**Comment i-251 and i-252**

**Reflections on darshan\_13\_0917 proposed fixes for i-251 and i-252**

**Corrected fixes for i-251 and i-252**

Figure 145B–11 illustrates a PSE implementing CC\_DET\_SEQ=3 when the connection check result is dual.

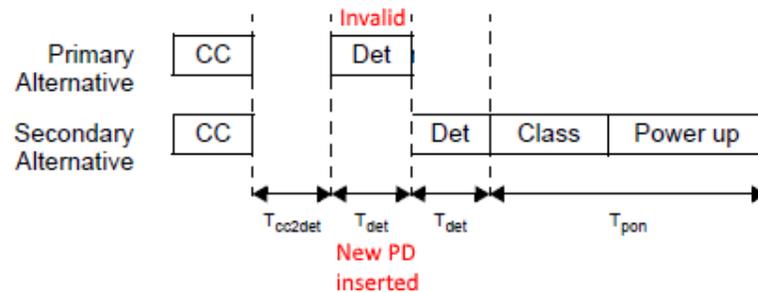
darshan\_13\_0917 creates the opportunity for a failed detection on the primary pairset to be followed by a successful detection and power-on on the secondary pairset. This will allow Tpon violations. Tpon violations may occur as do\_detect\_pri, even if invalid, can take up to 500ms, during which time the object connected to PSE PI may change.

The entire logic behind moving to an explicit description of the CC/DETECT sequences was to make impossible a PD removal-reinsertion during the entire CC-DETECT-CLASS-POWER sequences 0, 1, 2 and 3 for both single and dual signature PDs. Instead of allowing the secondary to power on after the primary has failed (and is in WAIT\_PRI) we must instead require a new Connection Check.

Modify Figure 145-16 to allow return to

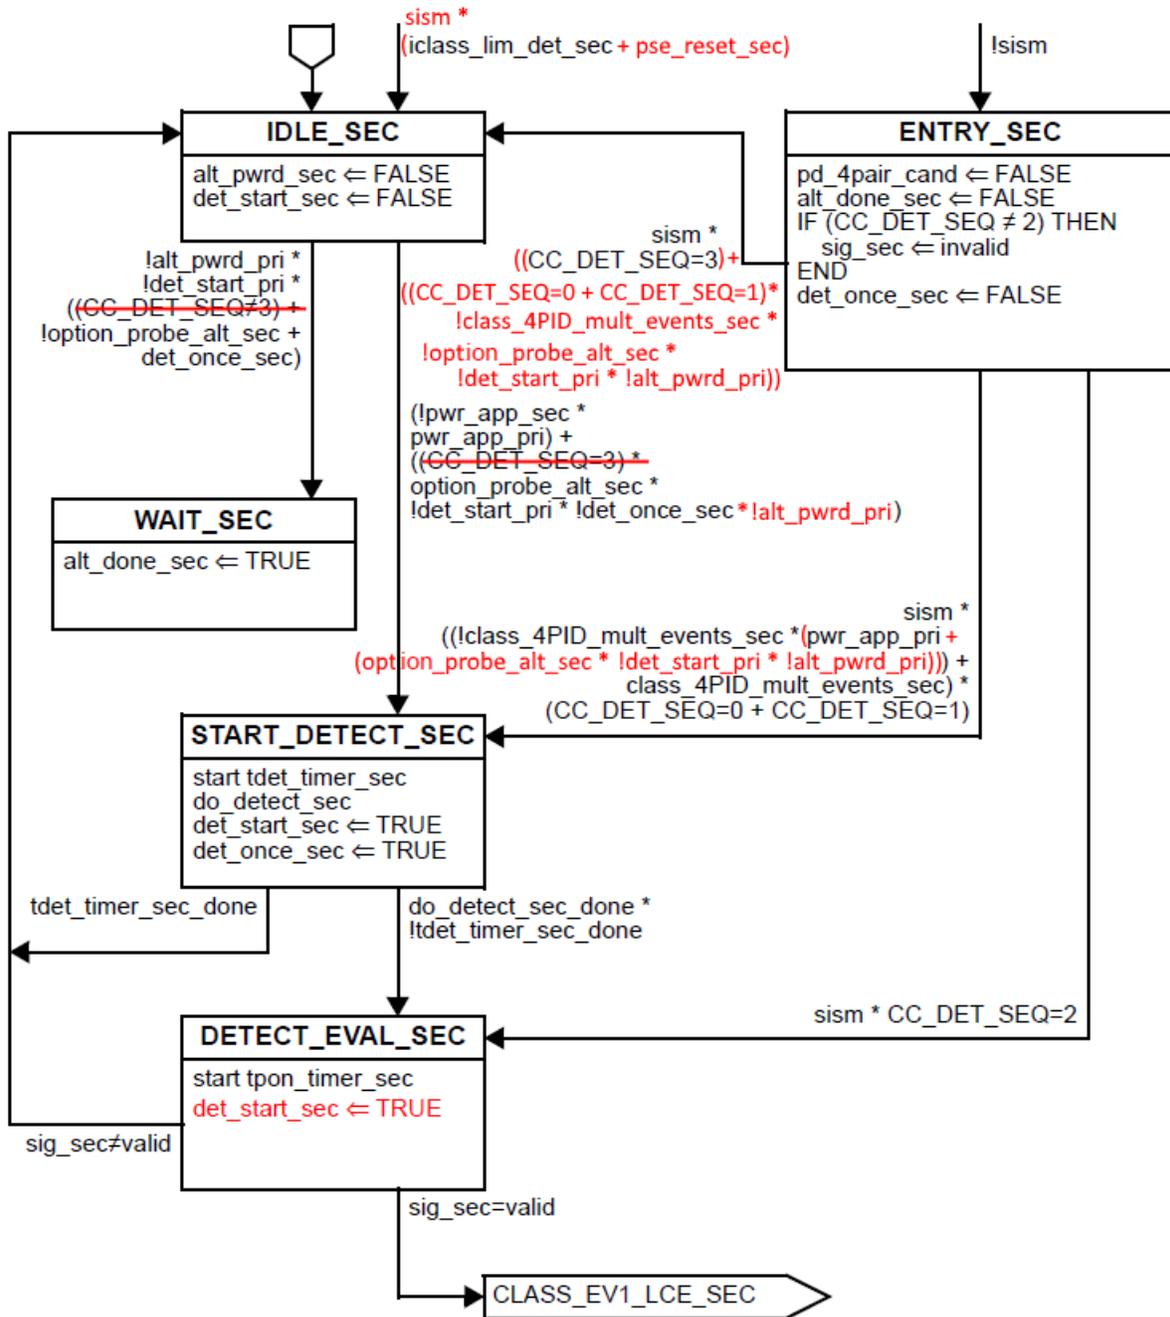
- add sism term IDLE\_PRI entry and allow pse\_reset\_sec
- Allow SEQ0/1 to exit ENTRY\_SEC to IDLE\_SEC if staggered detect fails on primary for any reason (!valid or tdet\_timer\_done)
- Fix SEQ3 IDLE\_SEC to START\_DETECT\_SEC to move uniformly to START\_DETECT\_SEC
  - o Was moving after class in one case and after powerup in the other
- Grant option\_probe\_alt\_sec behavior to SEQ0/1 in ENTRY\_SEC to START\_DETECT\_SEC arc

Modify Figure 145-16 to

- Properly terminate an "inspection only" option\_probe\_alt\_sec.
  - o This implies staggered detects cannot power secondary if primary detect result is invalid
  - o Also preserves tpon
